CIRCULATION	GENERAL
	SUFFIX
PAPER	AMENDT.
	W
WIRING CHANGES TO ISSUE 6 OF SW120418.10.62/A

SWITCHBOARD NIO70

CORD CIRCUIT MODIFIED TO PREVENT RELEASE TO METER PULSES.
 WORKS SPECIFICATION S (W) 2044 AND
 E. I. TELEPHONES P.B.X.'S. B 3106 REFER.

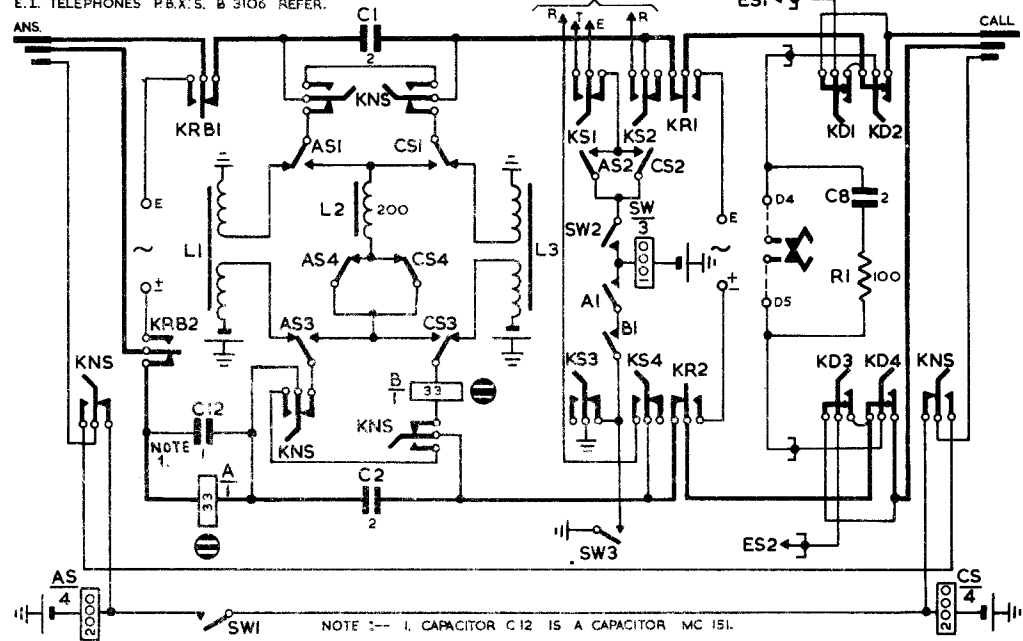
NOTE 1:-- 1. CAPACITOR C12 IS A CAPACITOR MC 151.
